**SUPPORTING AND ADDITIONAL MATERIAL FOR PROPERTY: 6541 ORIOLE Dr. Dallas, TX 75209**

## STRUCTURAL INVESTIGATION & REPAIRS PHASE 1

# The Cockrum Residence

## Structural Review of Construction

SECOND FLOOR FRAMING  
PLAN

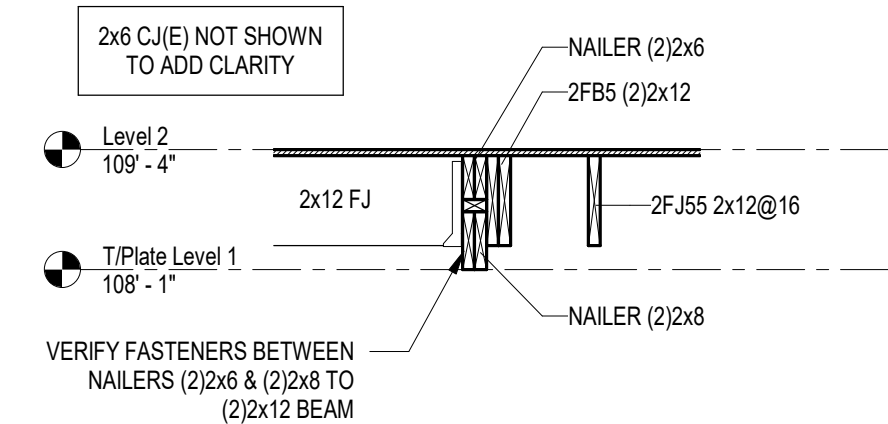
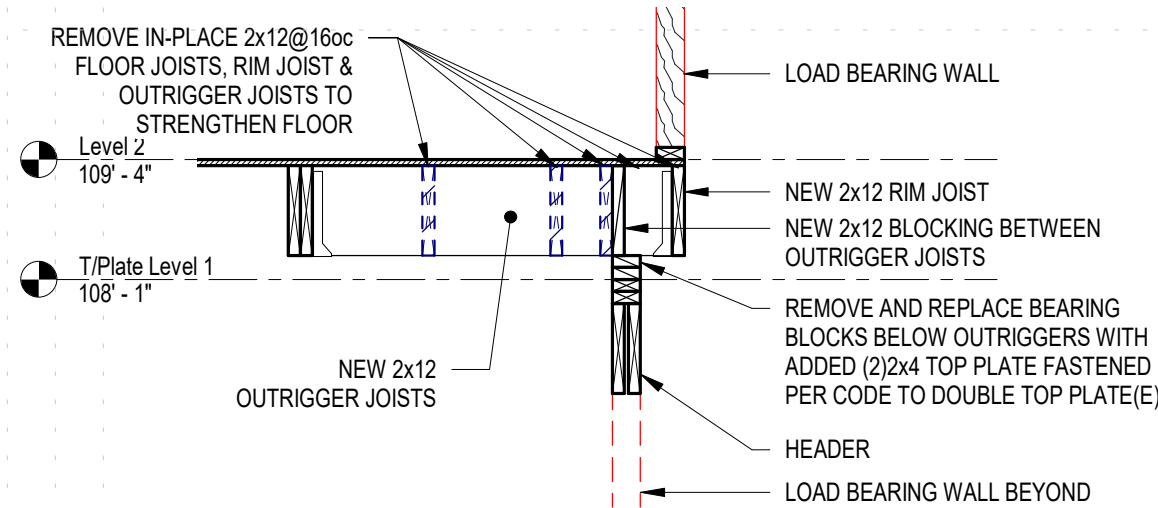
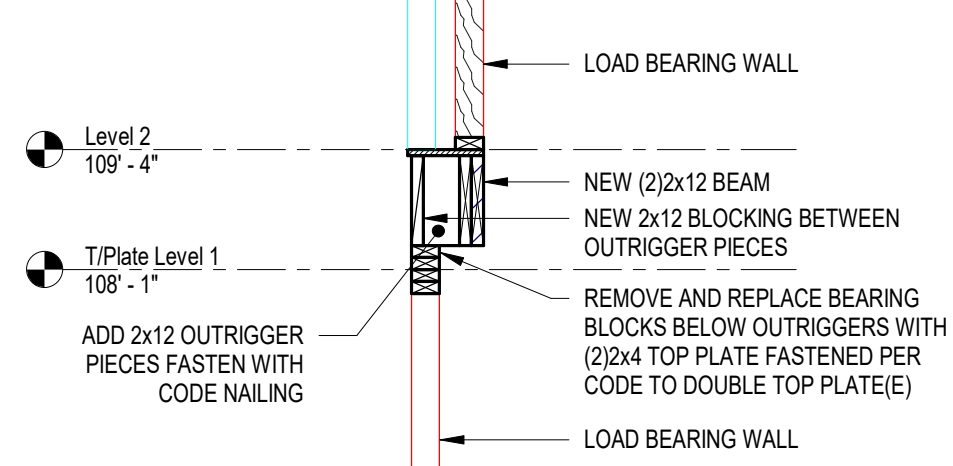
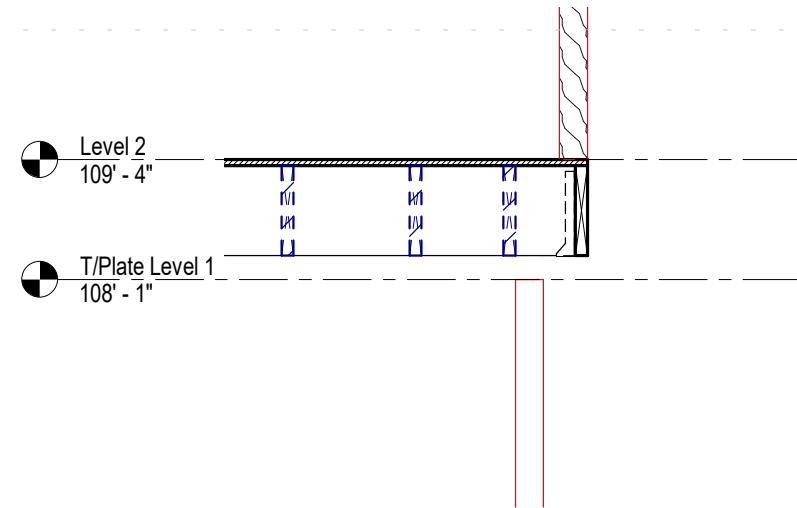
15. Some of the new ceiling framing is overloaded. *See structural drawings for overloaded members and the replacement member sizes.*
16. Some of the new and existing 2<sup>nd</sup> Floor framing is overloaded. *See structural drawings for overloaded members and the replacement member sizes.*

17. Some of the existing headers are overloaded. *See structural drawings for overloaded members and the replacement member sizes.*
18. Outrigger joists are a huge problem at the west and north walls. The short outrigger joists do not meet building requirements and will require extensive work to remedy. *Structural drawings indicate a framing solution only for the west wall overhang condition.*

MEMBER	REPLACE/ NEW	REPLACEMENT / REMEDIAL / NEW MEMBER	Comments	CONNECTOR L.E.	CONNECTOR R.E.	JST HANGER L.E.	JST HANGER R.E.
2FB1 (2)x12	Yes	(2) 1.75X11.875 LVL	OVERLOADED BEAM				
2FB2 GL3.5x14	Yes	(3) 1.75X14 LVL	OVERLOADED & DAMAGED BEAM AND REROUTE PLUMBING				
2FB3 (3)1.75x14LVL	Yes	(4) 1.75X14 LVL	OVERLOADED BEAM				
2FB4 (3)1.75x11.875LVL	Yes	(3) 1.75X14 LVL	OVERLOADED FASTENERS & DAMAGE AT JOIST HANGER REQUIRES BEAM REPLACEMENT				
2FB5 (2)x12	Yes	(2) 1.75X11.875 LVL	OVERLOADED BEAM				
2FB10 (3)x12	Yes	(2) 1.75X11.875 LVL	OVERLOADED BEAM				
2FB11 2x12	Yes	(2) 1.75X11.875 LVL	OVERLOADED BEAM				
2FB21 (2)x12	Yes		NEW BEAM	UPLIFT CONNECTOR TBD	UPLIFT CONNECTOR TBD		
2FB31 (2)x12	Yes		NEW BEAM	UPLIFT CONNECTOR TBD	UPLIFT CONNECTOR TBD		
2FB81 (2)x12	Yes		NEW BEAM	UPLIFT CONNECTOR TBD	UPLIFT CONNECTOR TBD	HUC 210-2	
2FBC1 (2)x12	Yes		NEW BEAM. FASTENERS @ HUC HANGER USE (6) SIMPSON SDW2300 SCREWS FAR SIDE OF BEAM	UPLIFT CONNECTOR TBD

## ROOF FRAMING PLAN

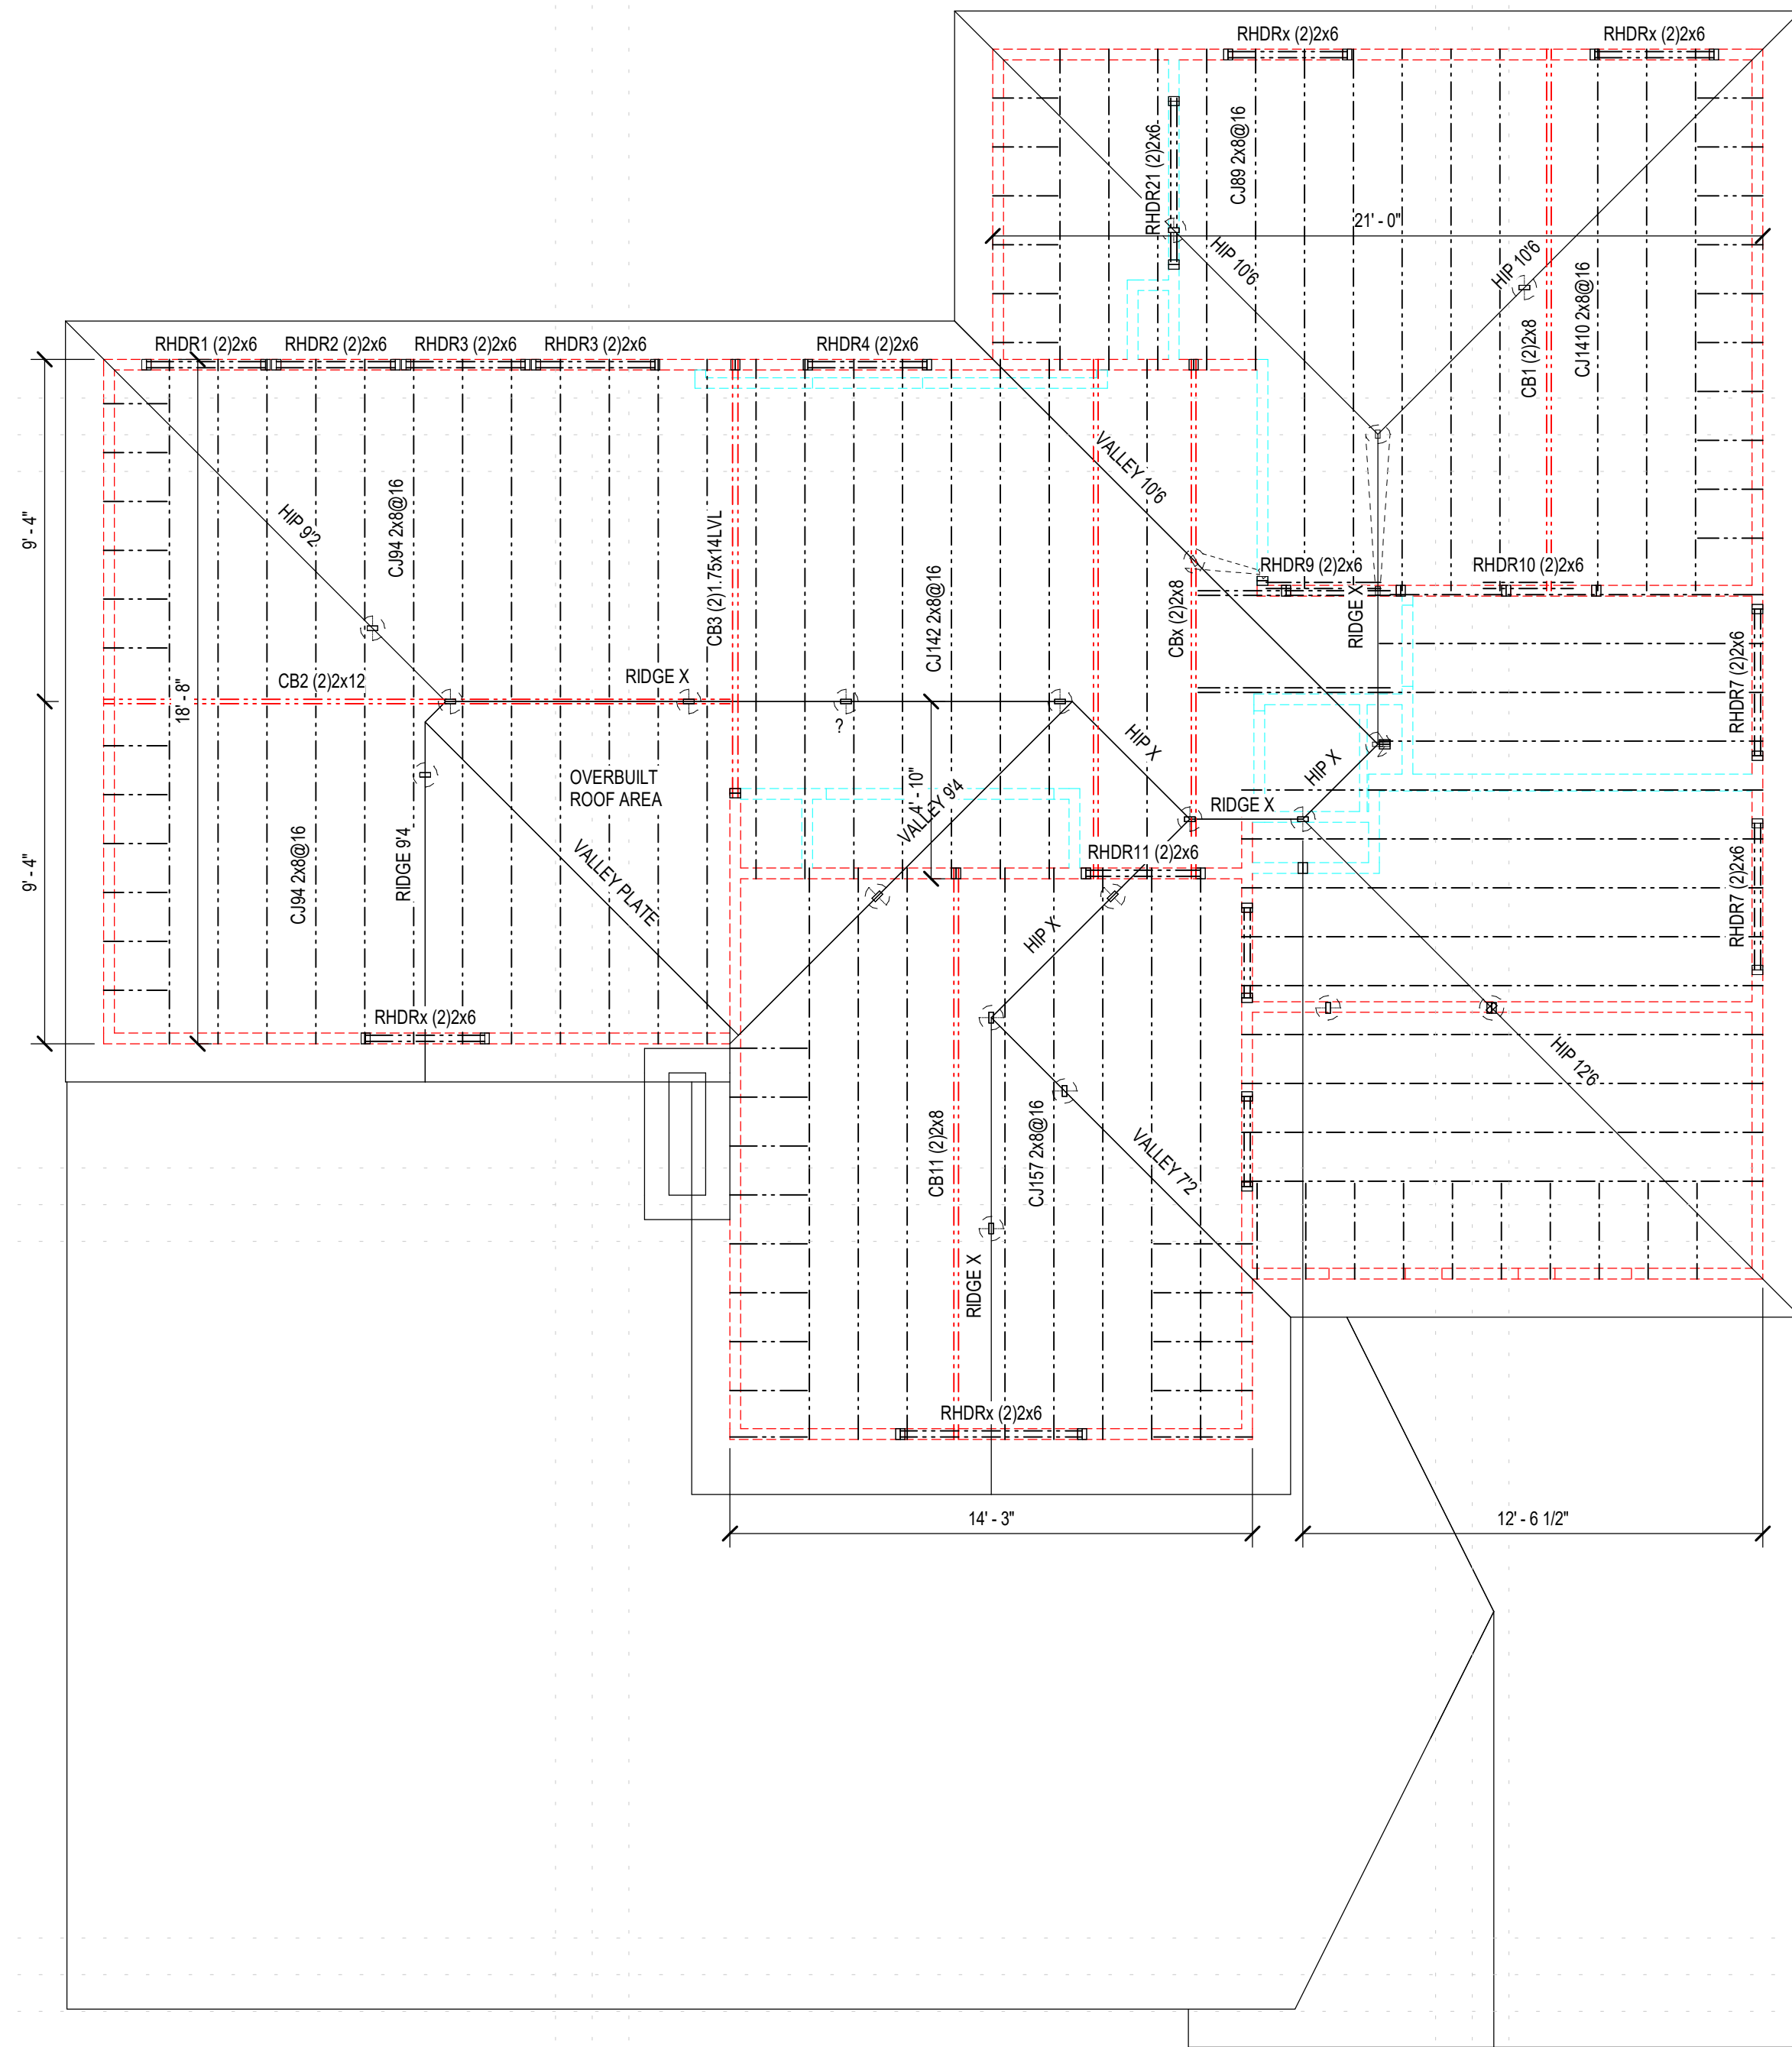
1. Roof rafters not fastened to ceiling joists per code. IRC R802.3.1, R802.3.2, Table 802.5.1(9) This condition cause the ridges, hips and valleys to support gravity and wind loads. The posts between the ridges, hips and valleys, and the ceiling framing and the second floor walls transfers concentrated gravity loads to the framing below. These concentrated gravity roof loads supported on the ceiling framing and second floor walls transfers onto the second framing overloading much of the second floor framing below such areas.

7. Posts below ridges, valleys and hips are supported on the ceiling joists and second floor walls. The loads from roof and ceiling framing transfers down to second floor framing. See IRC Figure R802.5.1 ***The second floor framing where supporting roof and attic framing is predominantly overloaded.***

RR21 2x6@24	Yes	ADD 2x6 SISTERS FULL LENGTH	OVERLOADED RAFTERS				
RR22 2x6@24	Yes	ADD 2x6 SISTERS FULL LENGTH	OVERLOADED RAFTERS

Photo 1

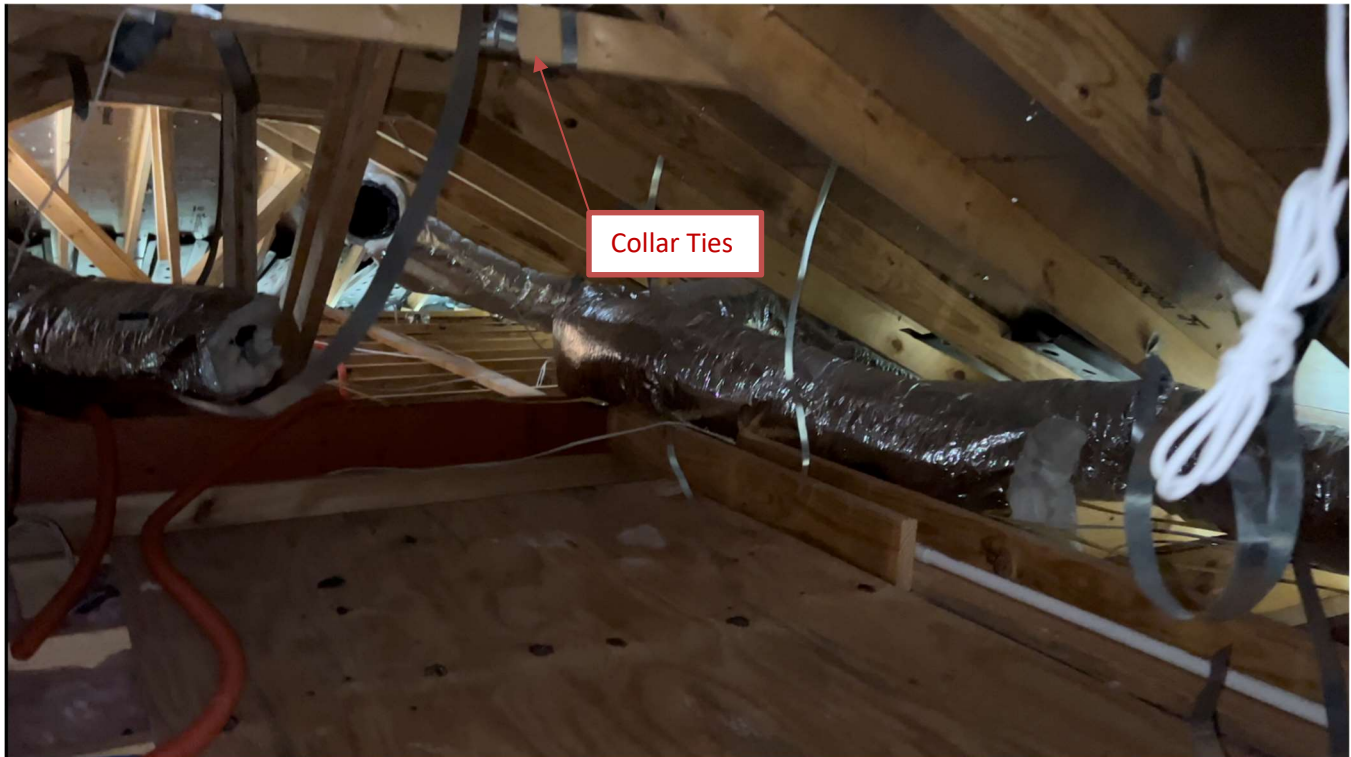
These collar ties can be seen in **[Photo 1]**. However, not all rafters had collar ties and thus collar ties are to be added to the framing in the areas they were omitted as seen in **[Photo 2]**. See [Detail 1](#) for the recommended repair detail.

Photo 3

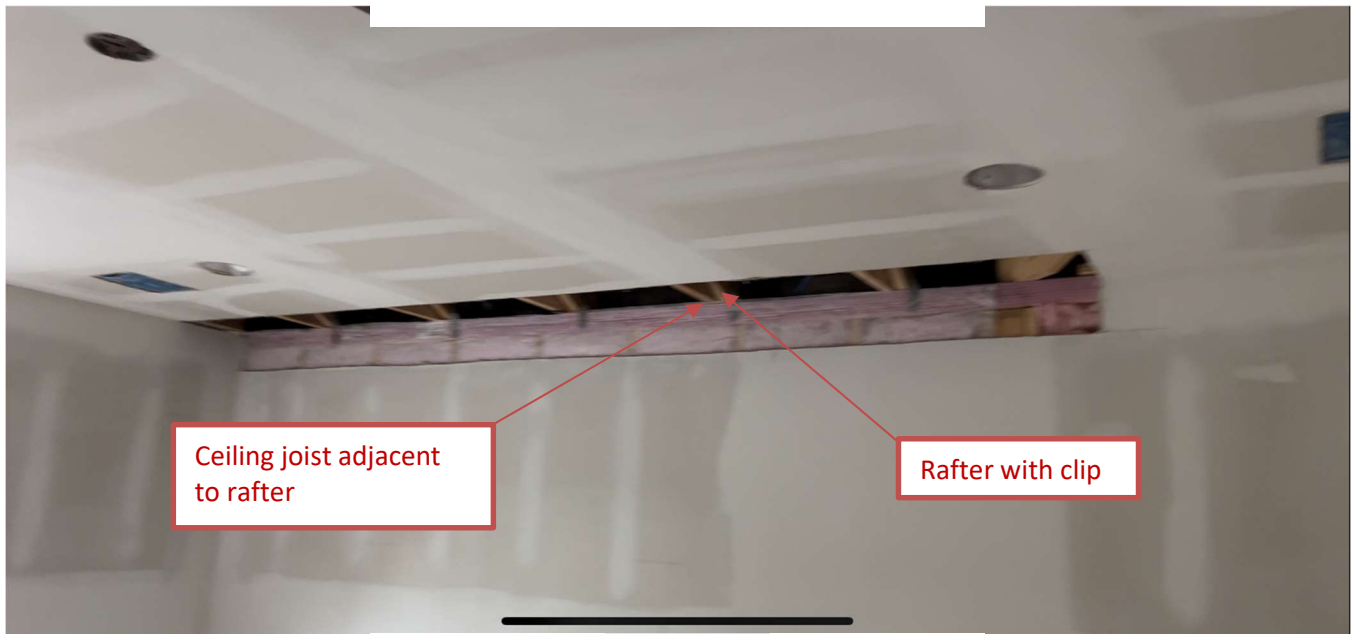
To keep the bottom of the rafters from uplifting off the wall, a metal clip is used attaching the rafter to the wall as can be seen in **[Photo 3]**. These clips were added after-the-fact as noted by the removal of the sheetrock and the attachment of the clips over the membrane instead of under it. However, it is not known whether these clips were added everywhere. For example, behind the shower wall as seen in **[Photo 4]**. These clips need to be in place prior to finishing construction.

Detail 2

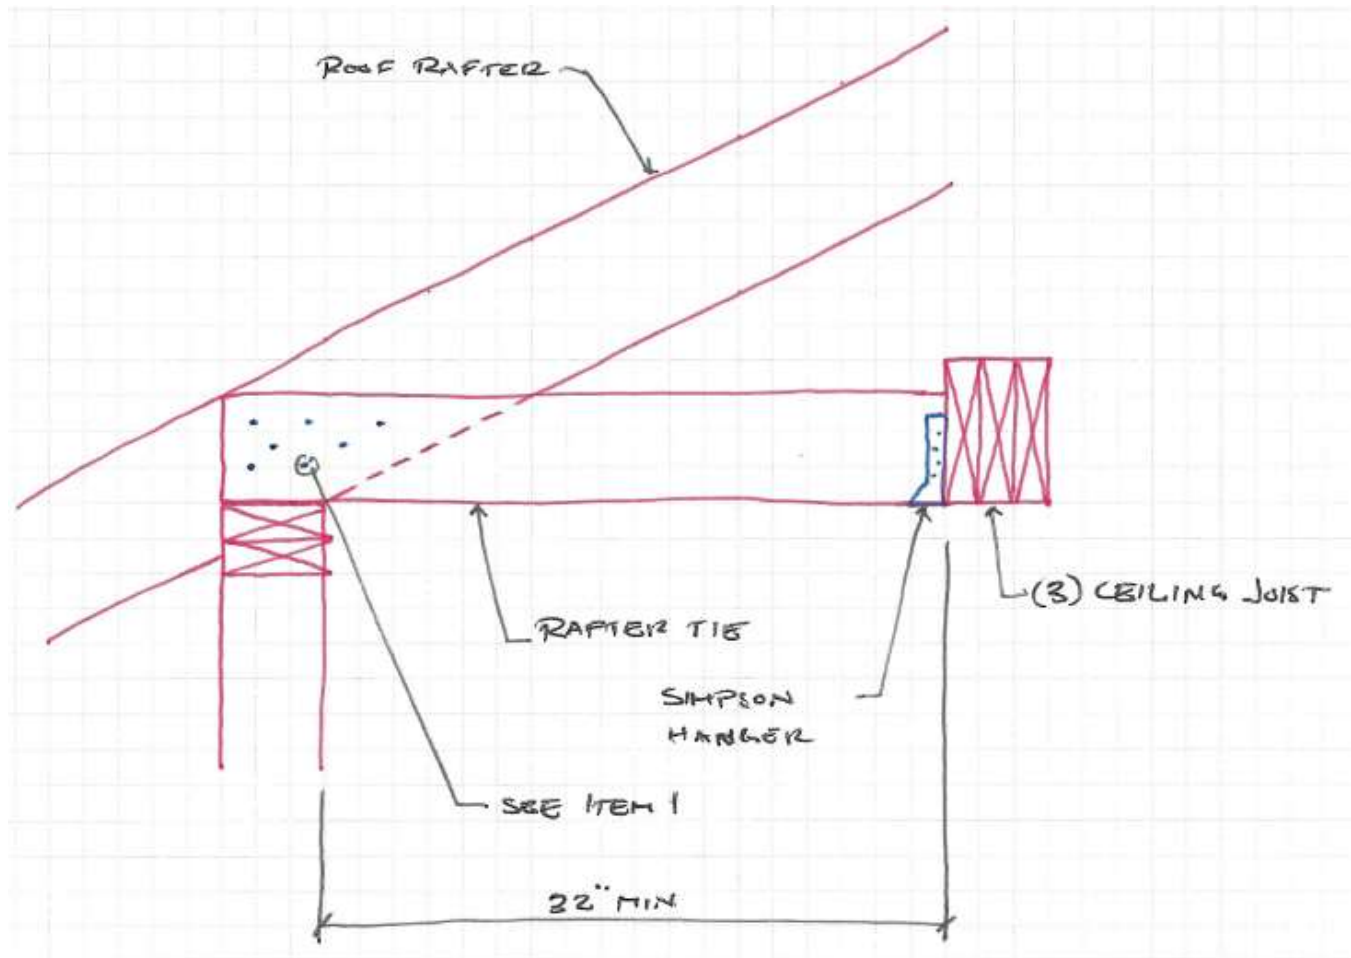
The roof rafters also see the effects of gravity and objects, animals, and people on top of them. These forces and loads force the rafters down. As those rafters move down, because of their length and slope, they push the walls out. To counteract this outward force on the walls and downward force on the rafters, ceiling joists are nailed to the rafter ends at the top of the walls to act as tension members and completing a field-built truss. These ceiling joists ensure that everything stays in its place. **[Photo 3]** shows a good example of the ceiling joists framed to the roof rafters. **[Photo 5]**, on the other hand, shows ceiling joists not tied to the roof rafters. The repair for this condition will require additional ceiling joists placed adjacent to and nailed to the roof rafters as indicated in [Detail 2](#).
